Licence Number	L7774/2000/6
Licence Holder	Robe River Mining Co Pty Ltd
ACN	008 694 246
File Number:	DER2014/000873
Premises	West Angelas Iron Ore Mine AML70/248 sections 71, 72 and 79, L47/50, L47/52, L47/53, L47/60, L47/409, E47/2963, G47/1236 and G47/1235
Date of Amendment	03/05/2019

Amendment

Amendment Notice

ATTACHMENT 3A – Location of Village WWTP3, Spray field, and Bulk fuel storage

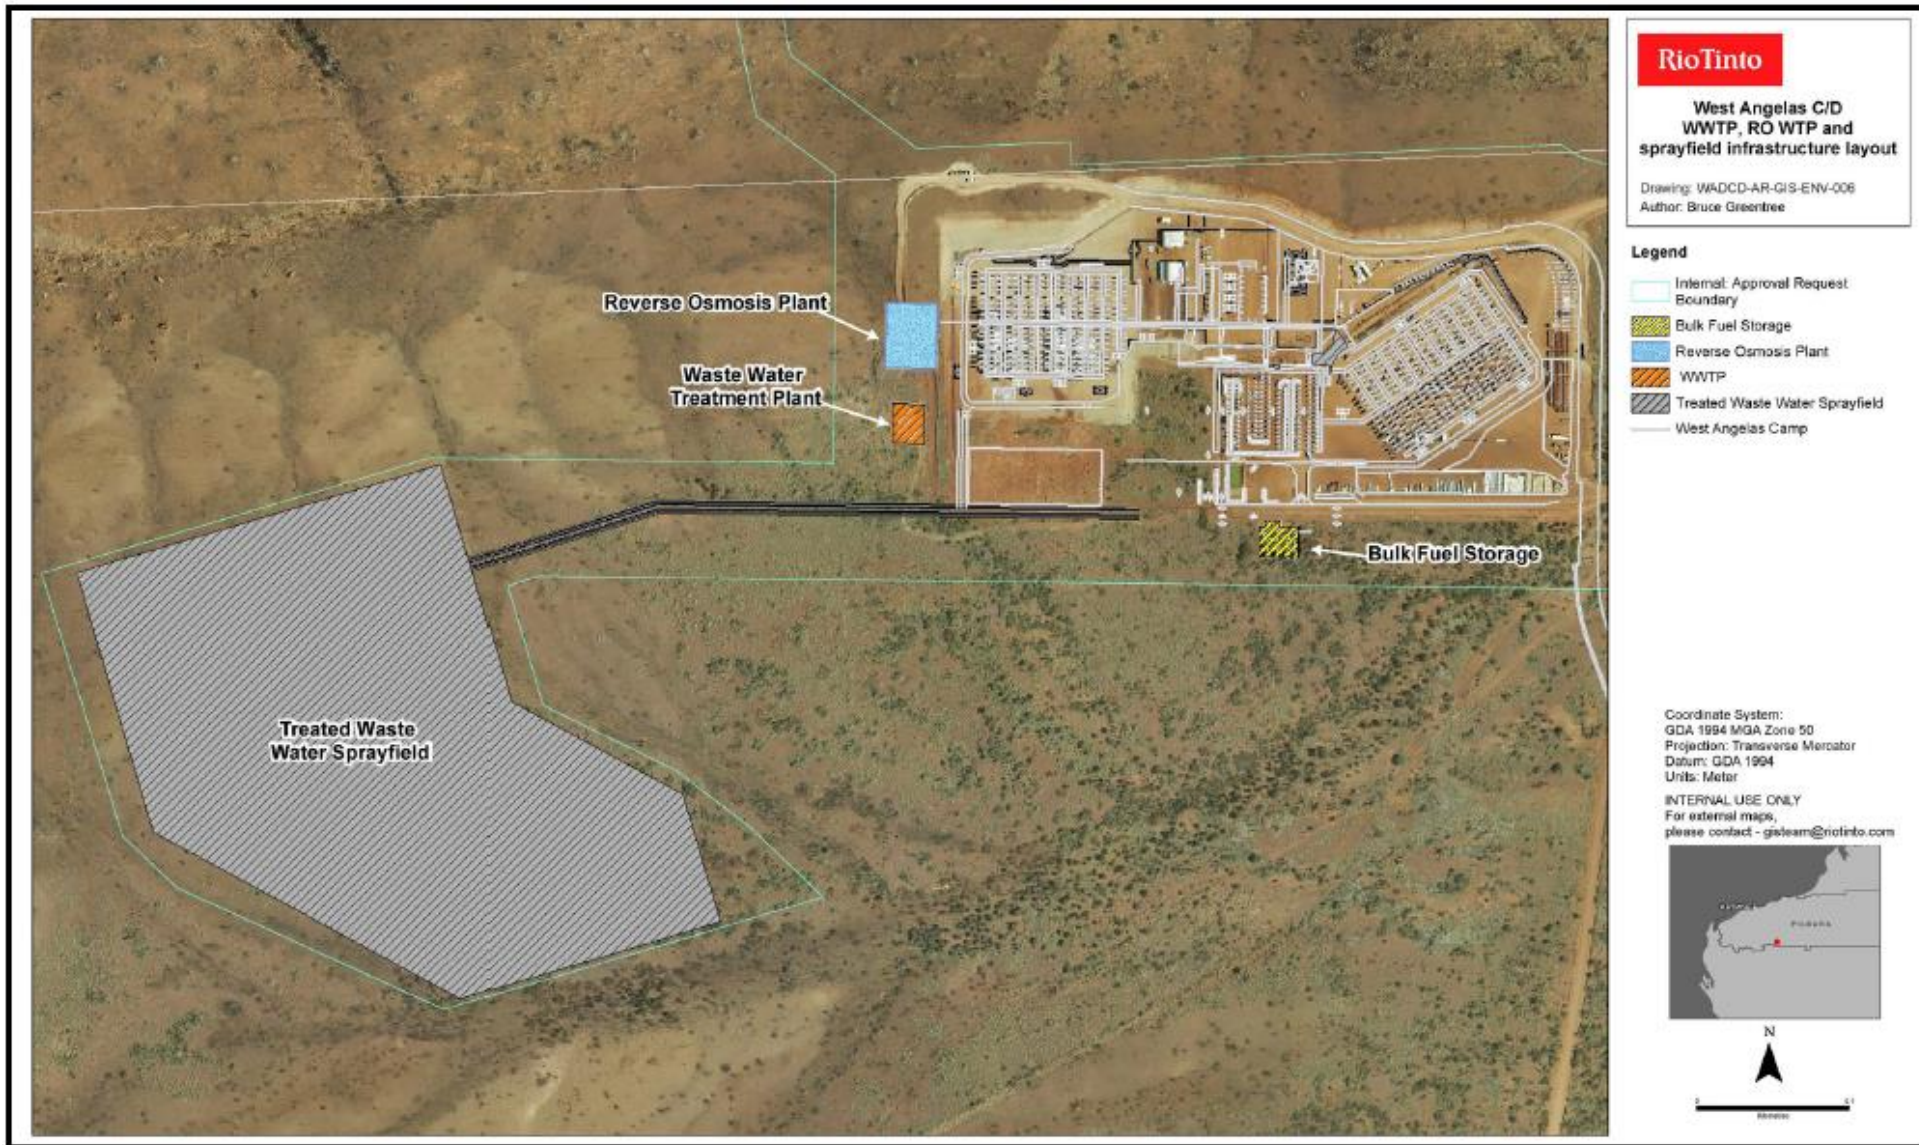
Condition 1 is amended to include the RO reject water as a discharge and to include the location of the irrigation spray field by new location map Attachment 3A.

- The Licensee shall ensure that all effluent discharged consists only of treated sewage and is discharged to the irrigation sprayfields depicted in Attachment **3, and only treated sewage with up to 30 cubic metres per day of Reverse Osmosis**

Water Treatment Plant reject water is discharged to the irrigation sprayfield depicted in Attachment 3A.

7. The Licence is amended by the insertion of Attachment 3A as shown below, as a map locating the Village WWTP3, irrigation spray field and the fuel facility.
